## CENTREVILLE PLANNING COMMISSION

August 21, 2024

- VI. **Appearances**
  - a. Variance Request for Driveway/Walkway in the Critical Area Buffer – 110 Watson Rd, Darryl Savage, Owner
  - b. Concept Subdivision and Site Plan for proposed commercial development on proposed Lots N, O and P, Centreville Business Park, Coursevall, LLC, Owner; Kevin J. Shearon, P.E., LEED AP, DMS & Associates, LLC

**RE: CONCEPT SUBDIVISION AND SITE PLAN FOR A PROPOSED  
COMMERCIAL DEVELOPMENT ON PROPOSED LOTS N, O, AND P IN THE  
CENTREVILLE BUSINESS PARK, LANDS OF COURSEVALL, LLC  
Q.A. COUNTY TAX MAP 44E, PARCEL 98  
DMS & ASSOCIATES JOB #2023124**

**BUFFER MANAGEMENT PLAN**

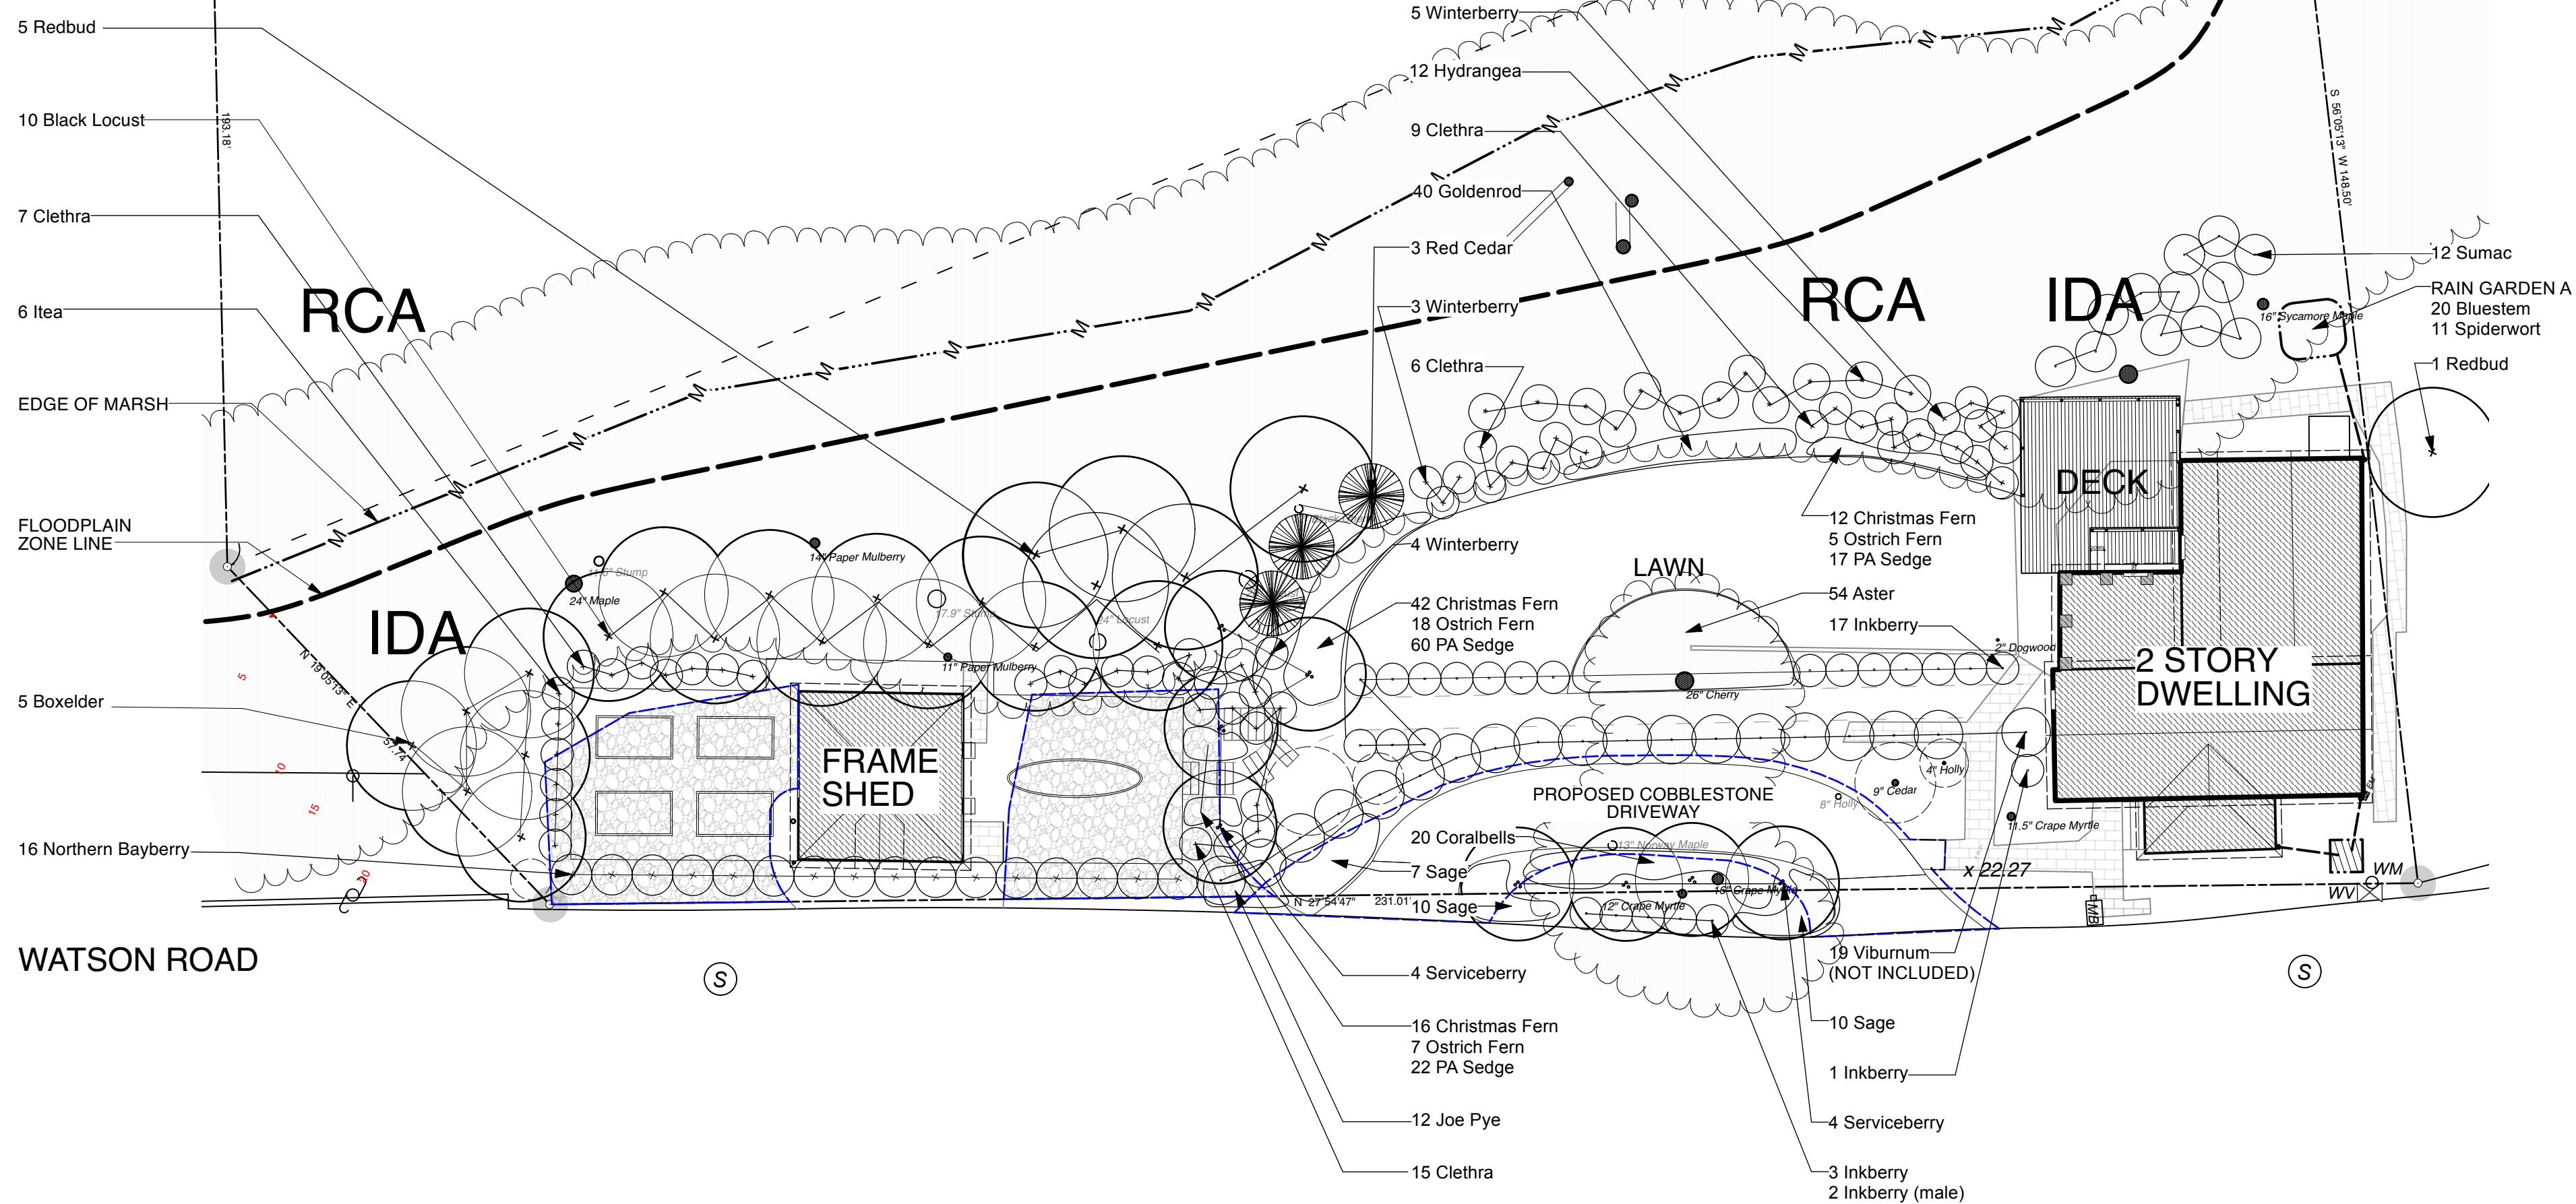
- Per COMAR 27.01.09.01.E(3), the Buffer must be delineated based on existing field conditions at the time of the development proposal and is measured at least 100 feet landward from the mean high water line (MHWL) of tidal waters, the edge of each bank of a tributary stream, and the upland boundary of a tidal wetland. Per COMAR 27.01.09.01.E(7), the Buffer must be expanded when it is contiguous to a steep slope, a nontidal wetland, a hydric soil, or a highly erodible soil.
- The plan shows several red lines labeled as Buffer. The red line currently labeled "100' Buffer to Edge of Marsh" appears to be the location of the 100-foot Buffer. However, it is

- Please have the applicant submit a revised plan showing an accurate Critical Area Buffer, expanded as required.
- In order to provide timely comments and based on observations made during the site visit and communication with Town staff and consultants, it is assumed that the entire project is located within the Critical Area Buffer. If revised information indicates that a portion of the project is located outside the Critical Area Buffer, then the comments in this letter regarding the variance request apply only to the portion of the project located within the Critical Area Buffer.

- The applicant is seeking a variance to locate a driveway and walkways in the Buffer. Total proposed new lot coverage within the Buffer is 1,365 sf. The applicant proposes to remove existing lot coverage within the Buffer. A variance is not required to remove lot coverage from the Buffer.

- If the Board does grant the variance, the applicant must provide mitigation in accordance with the Town's Critical Area program. Per COMAR 27.01.09.01-2.H, variances require 3:1 mitigation for Buffer disturbance.
- The applicant submitted a Buffer Management Plan (BMP) that proposes 10,617 sf of planting. In addition, twelve (12) trees will be planted offsite at a Town-owned property.
